UNITED STATES PATENT AND TRADEMARK OFFICE

| APPLICATION NO. | FILING DATE | FIRST NAMED INVENTOR | ATTORNEY DOCKET NO. | CONFIRMATION NO. |
|--|-------------|----------------------|---------------------|------------------|
| 10/765,391 | 01/28/2004 | Anthony Di Bitonto | B0224.0079 | 2535 |

Office Action Summary

DETAILED ACTION

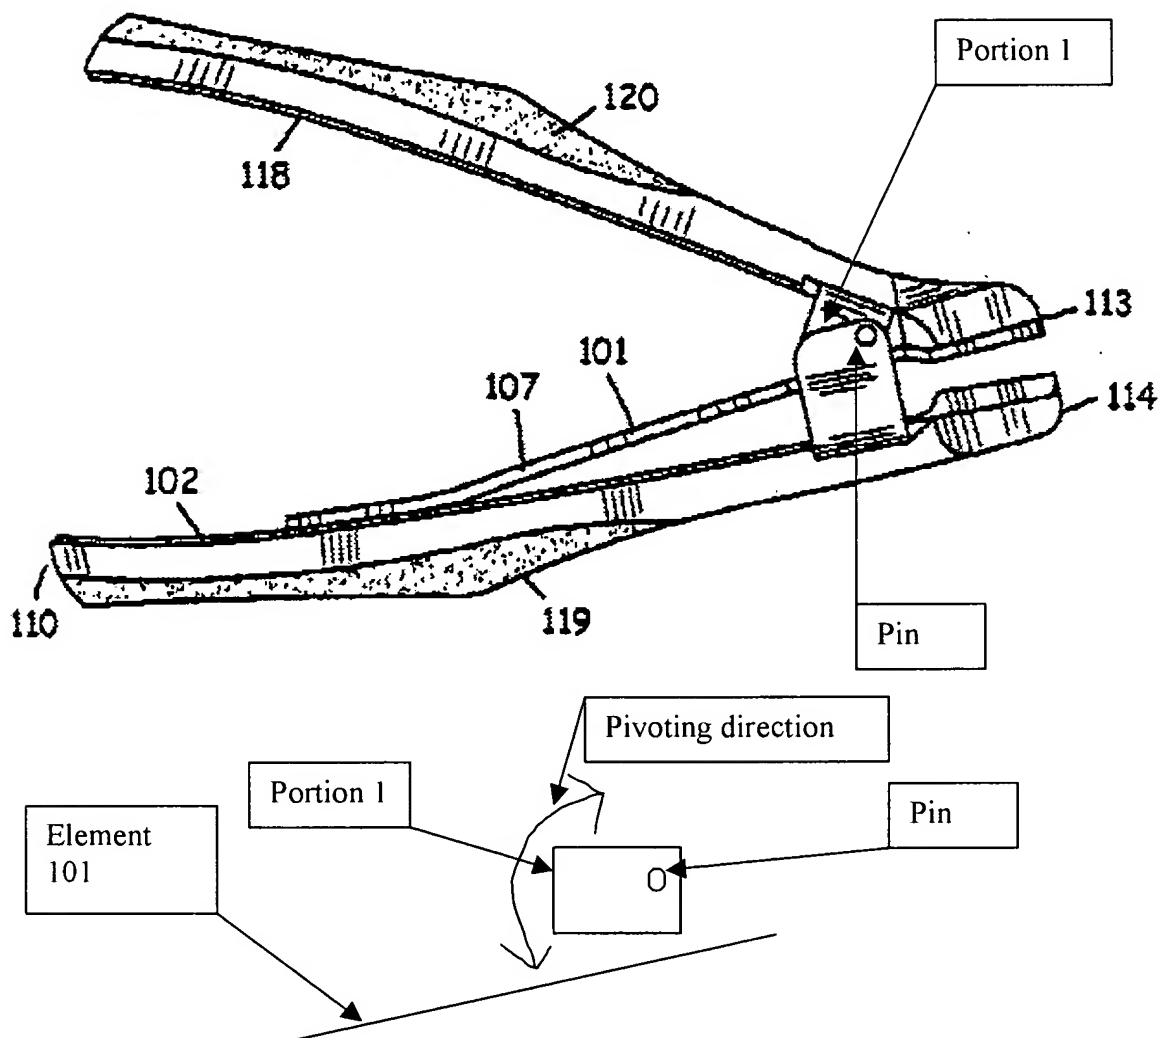
Regarding Applicant's argument with respect to the drawings, merely adding a label 117 to Fig. 5 does not overcome the drawing objection with respect to claim 1. The

corrected Fig. 5 does not show the post extending above the top surface of the top member. It appears that the nail clipper in Fig. 5 can function without the post. For example, portion 1 pivots about a pin to press down the top member. See below Figure and sketch. Therefore, more clarification of Fig. 5 is needed.

Regarding Applicant's argument with respect to the Specification, the structure of Fig. 5 is not clearly described the nail clipper as asserted. The limitation of the post

extending to above the top surface of the top member is not described in the Specification. The Specification only describes the structure in Fig. 4. As shown above, Fig. 5 could read on a different nail clipper structure. Therefore, objection to the Specification is proper.
